Re: Proposed Hidden Quarry
Noise Impact Study Report Addendum #1

This letter serves as addendum #1 to the Noise Impact Study¹ for the proposed Hidden Quarry development to address the following:

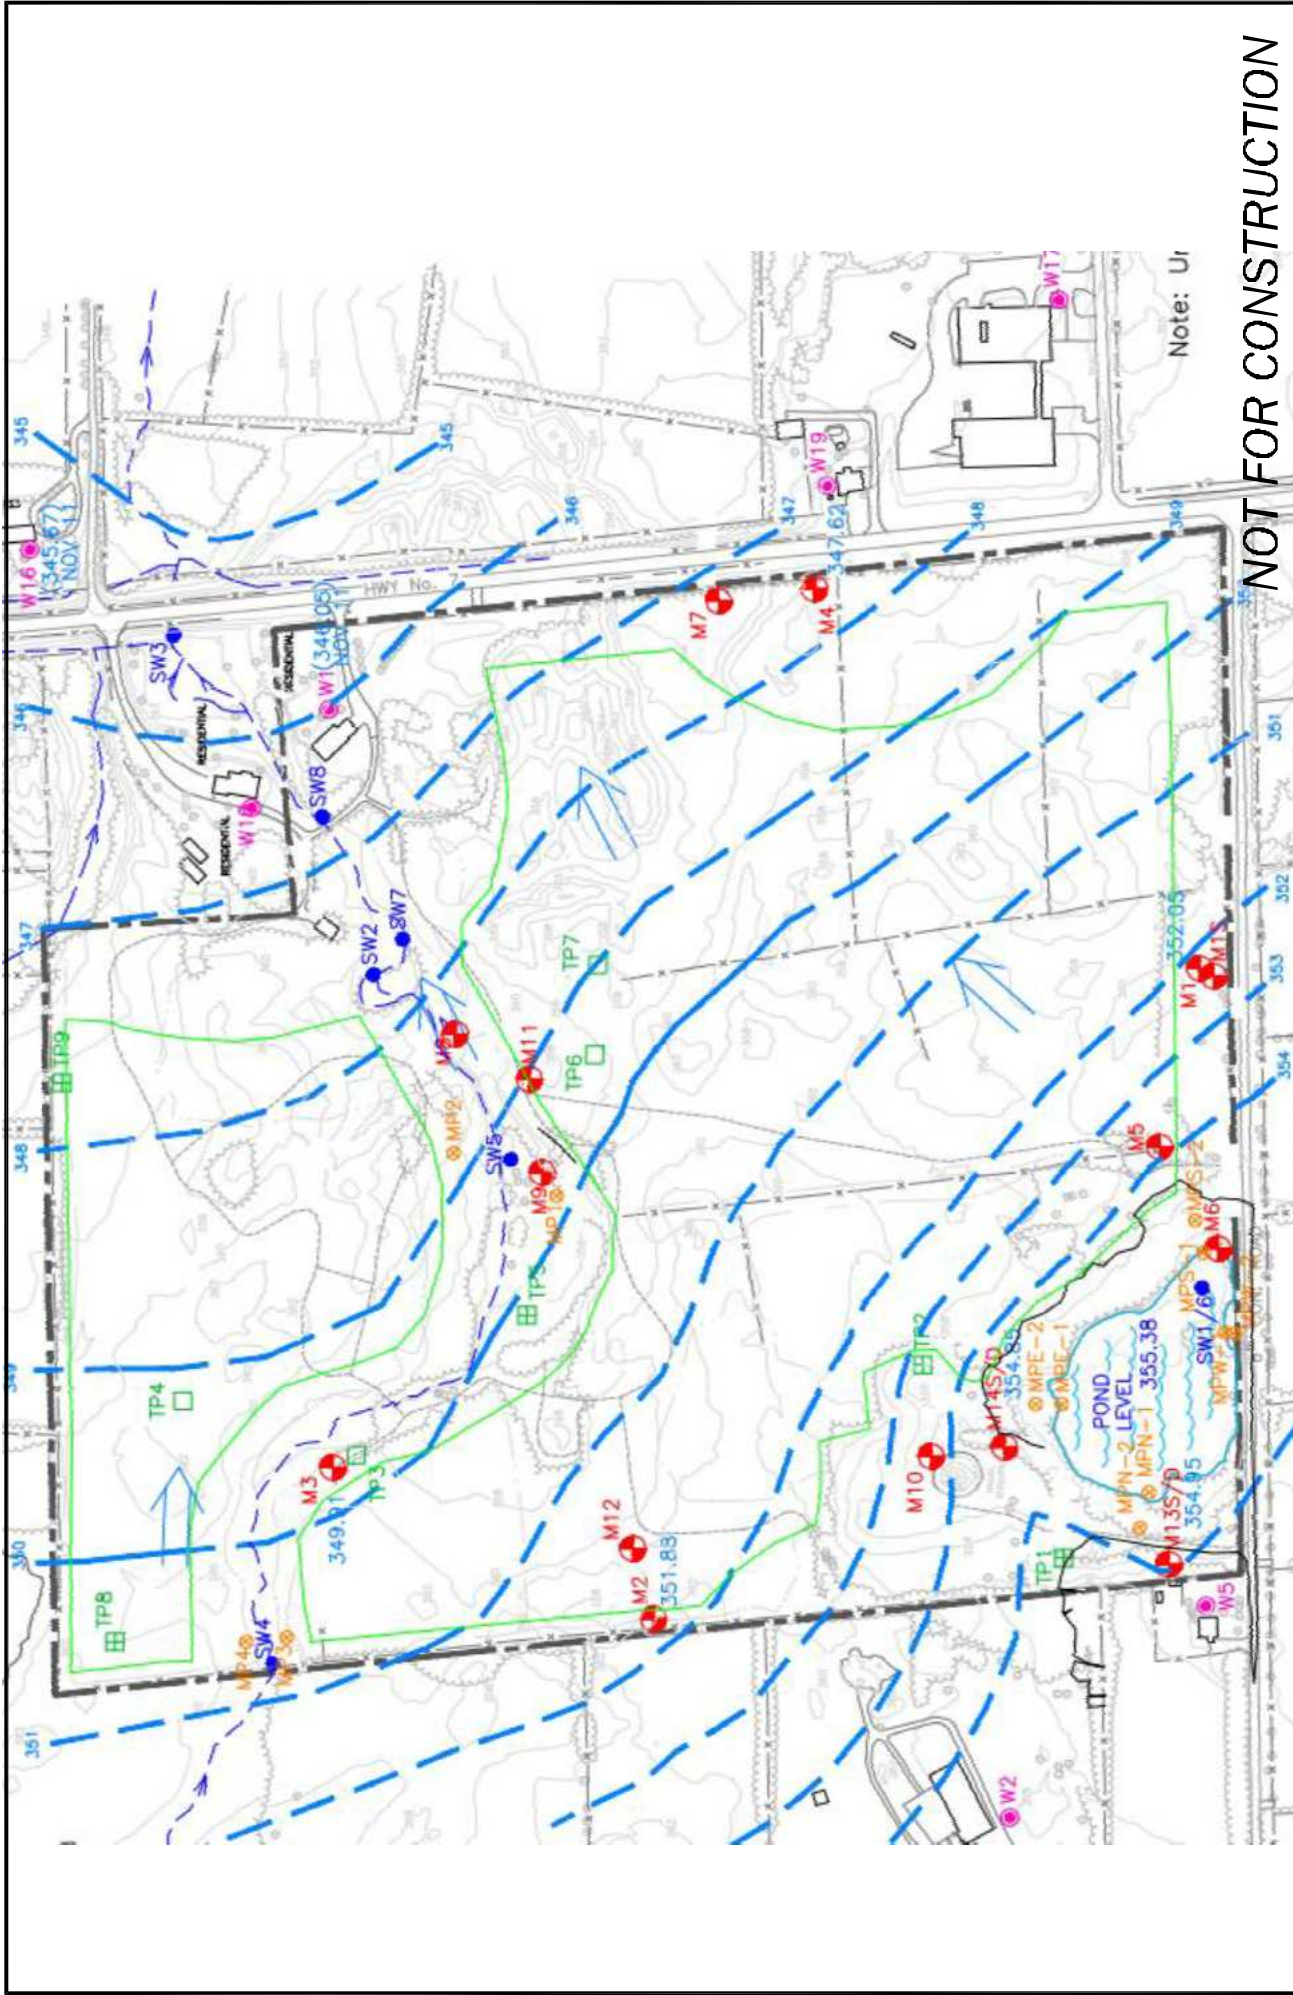
1. Revised quarry floor elevation height for high spring water elevation level
The high spring water level was measured to range from 346 masl to 354 masl across the site as shown in Figure 1. In the vicinity of the process plant location the high spring water level elevation is around 350 masl.

A revision to the noise model was required to accommodate the quarry floor remaining above the high water table, specifically in the processing plant area where the quarry floor has increased from 349 masl to 351 masl. The noise model used conservative quarry floor levels of 355 masl in phases 1 and 3 and 354 masl in phase 2.
2. Changes to on-site truck haul routes for phases
On-site truck haul routes for Phases 1, 2 and 3 have been updated based on the latest site plan.
3. Updated location of processing plant and stockpile locations
A minor reposition of the processing plant and stockpiles was implemented in the model to reflect the location shown on the latest site plan.

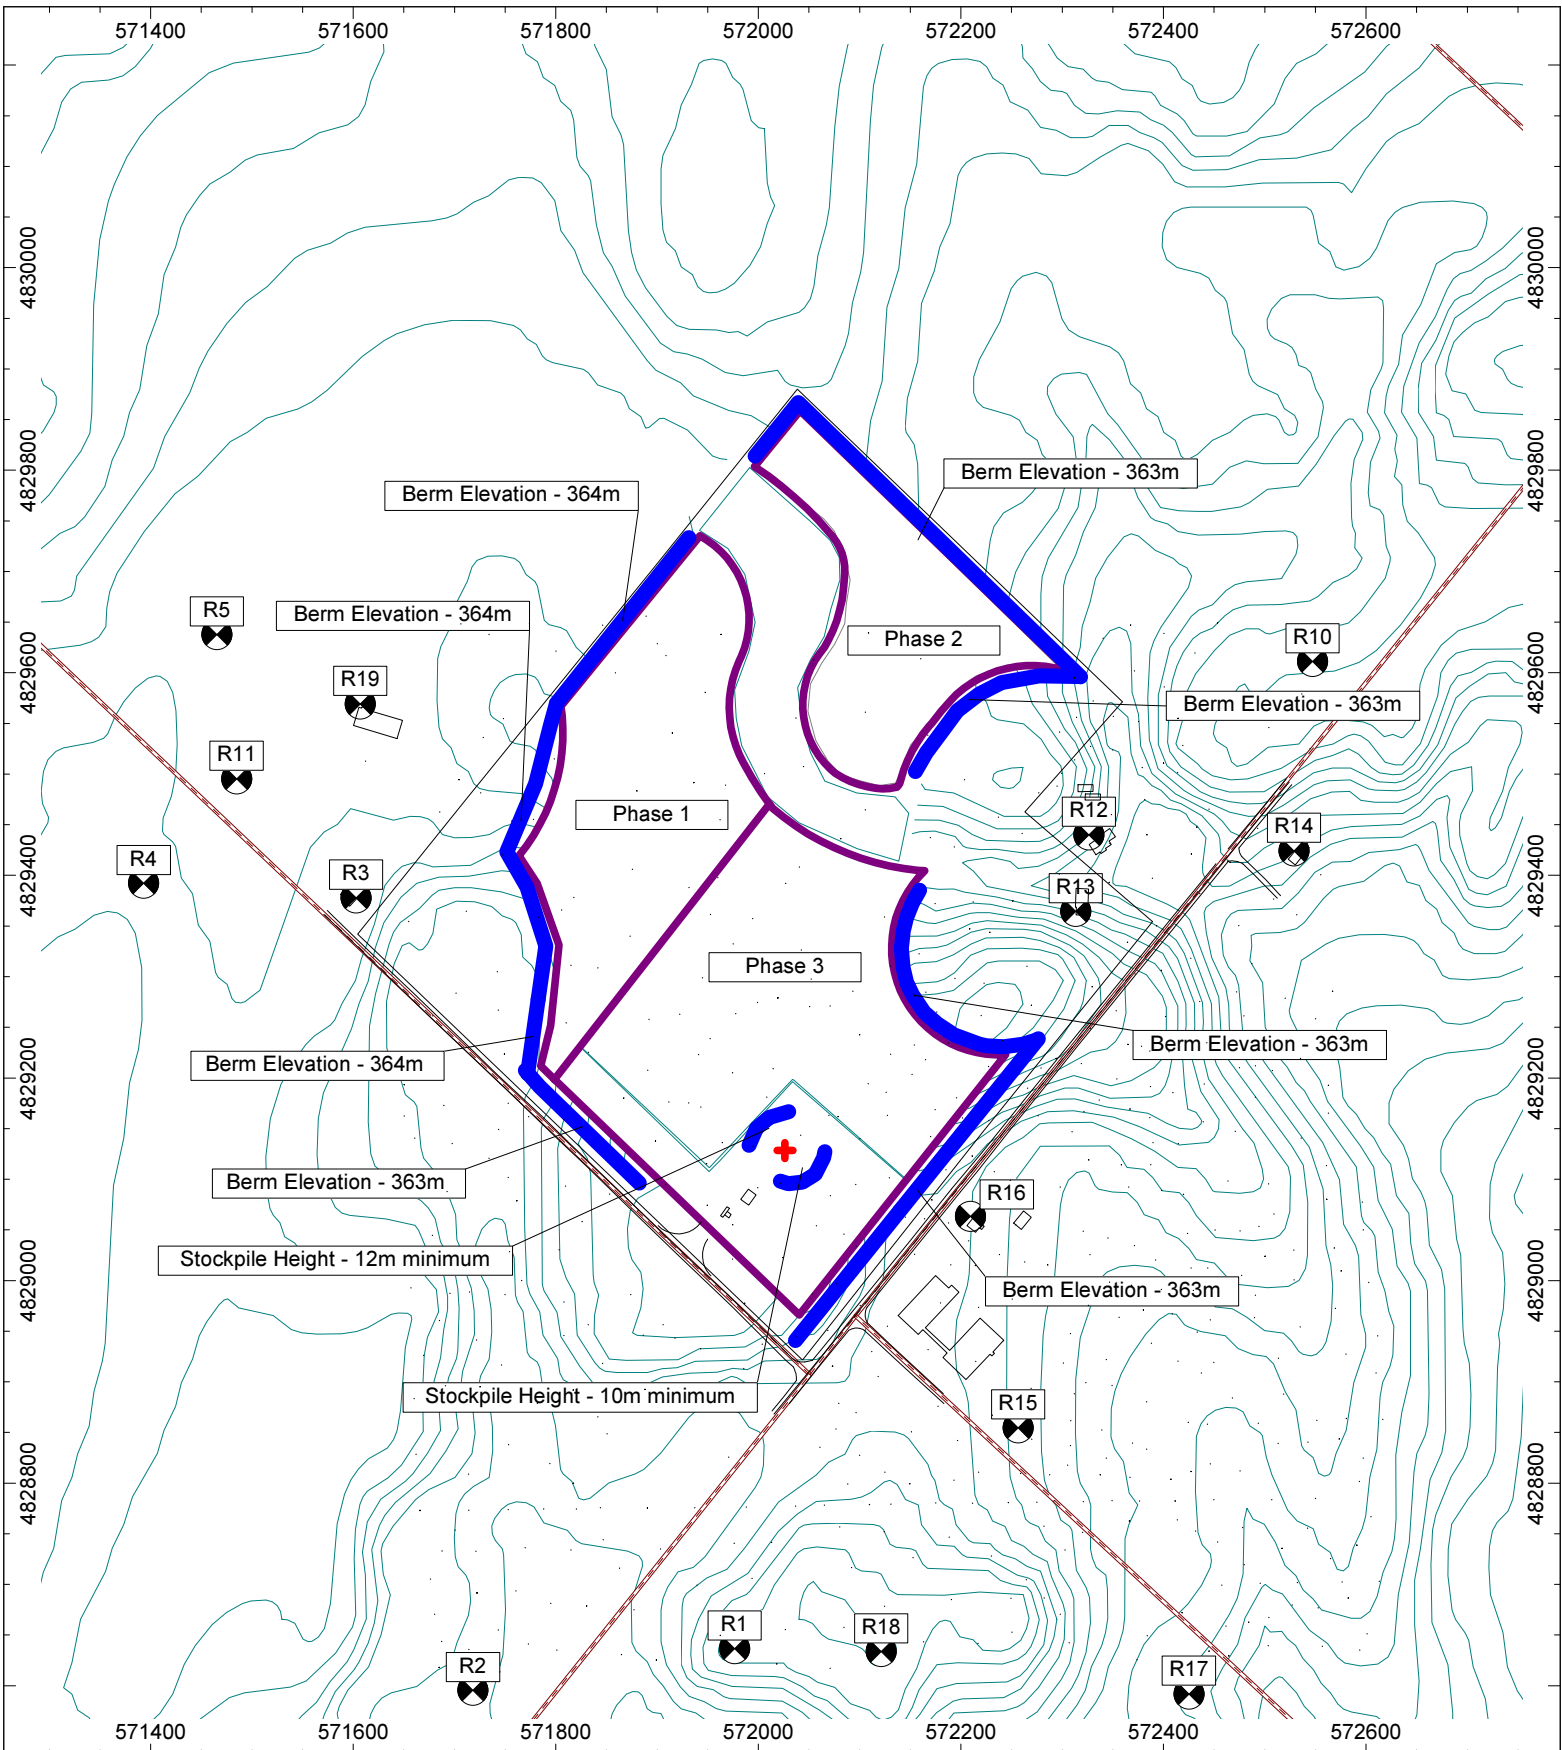
- 1) Quarry floor in the vicinity of the processing plant was changed from 349 masl to 351 masl.
- 2) The east portion of the 12 m stockpile shown on the site plan adjacent to the processing plant was extended to provide screening for R7.
- 3) Removal of recommendation for direction of extraction. There is no requirement to use the working face as a noise control measure. Perimeter berming is will provide sufficient screening.

1. 12m and 10m high stockpiles should be maintained in certain locations around the processing plant for each phase and stage. The stockpile peaks should be located no further than 30m from the processing plant, and should be located such that, in plan, they block line-of-sight between processing plant equipment and sensitive receptors, as described in the table below:

This configuration is shown in Figure 2.

2. A quiet drill with a maximum sound power rating of 112dBA should be used. This corresponds to a maximum sound pressure level rating of 75dBA at 30 meters.
3. Earth berms should be constructed to the elevations shown and located as shown on Figure 2.
4. The processing plant area should be established at an elevation of 351m, and a haul route trench connecting the processing plant area to the Stage 1 Phase 1 extraction area should be excavated to the same 351m elevation.
5. All construction equipment used in site preparation/construction must meet the sound emission standards defined in MOE publication NPC-115 and
